SEWAGE DISPOSAL SYSTEM

DEPARTMENT OF HEALTH AND MENTAL HYGIENE

A REPAIR

SUBDIVISION Beaufort Park LOT 7 BIK.C ROAD 8330 Reservoir Road

512790

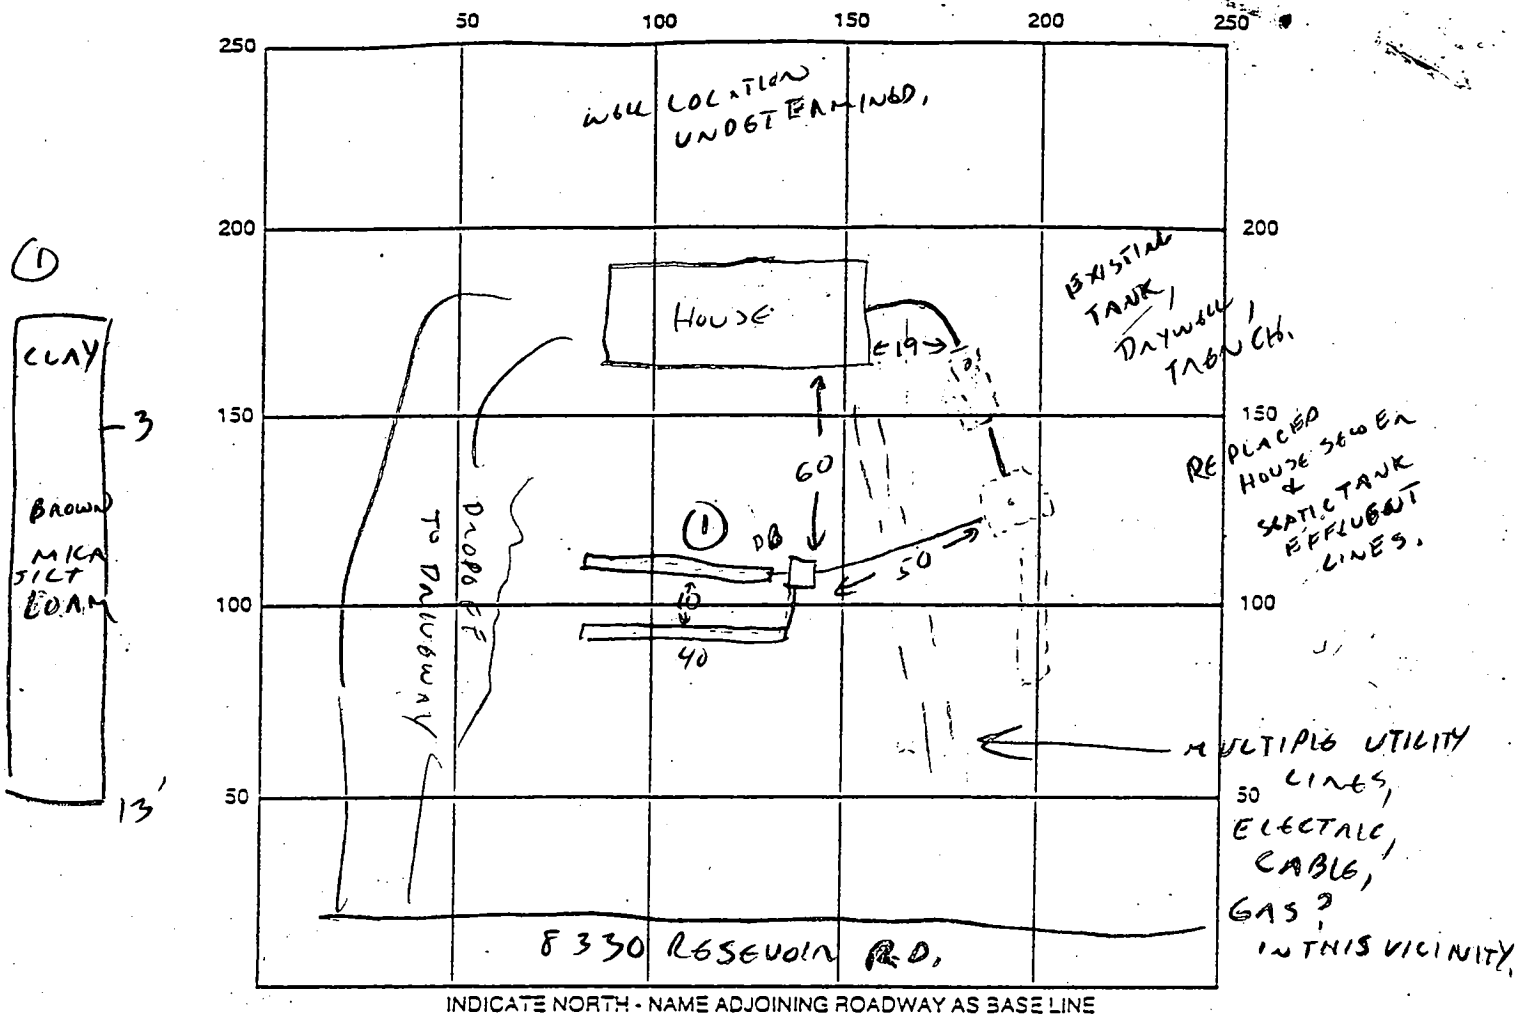
REMARKS: 11/3/99 OVERFLOW LINE ADDED TO DAYWELL FEEDING DISTRIBUTION BOX
SEALING TWO NEW TRENCHES. AREA BETWEEN DRYWELL & DIST BOX UNAVAILABLE
FOR DISPOSAL FIELD INSTALLATION DUE TO MULTIPLE UTILITY LINES. (CW)

11/4 TRENCHES COMPLETE - OK TO COVER. (CW)

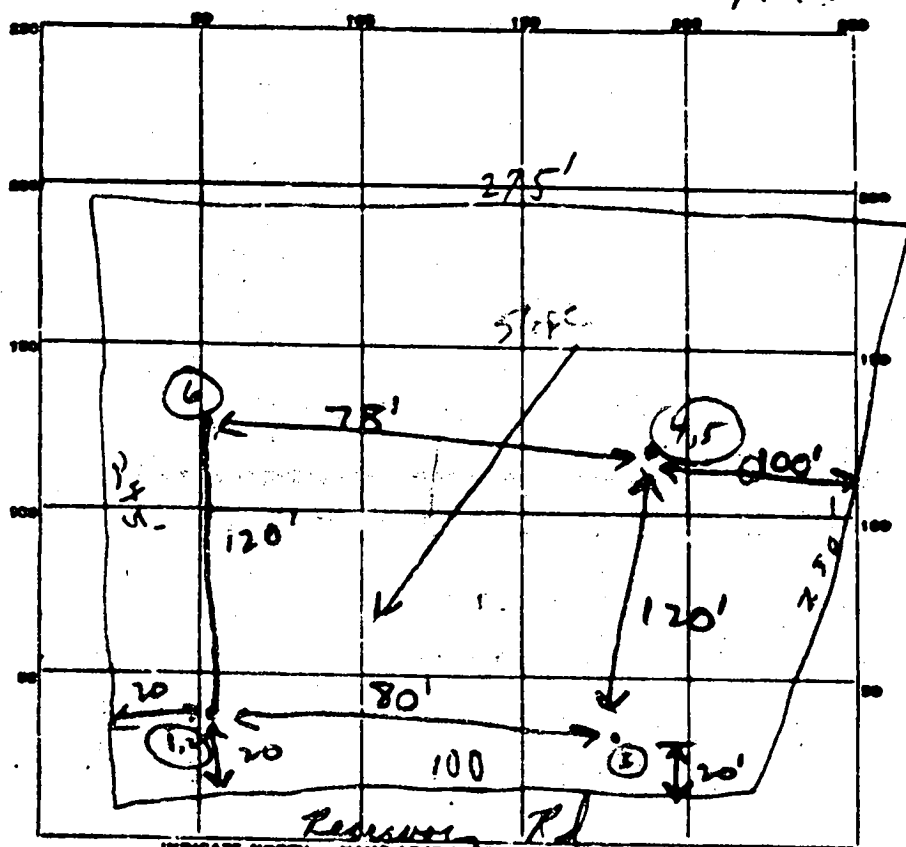
4/26/74 *Wish to see house - sewer connection,
and cleanout on ST. see note below*
WU?

new locations - observed D.W. being placed up about 35' to right of hole

*Cast iron sewer pipe was installed from house to septic tank
with proper fall and in harmony with county regulations.*
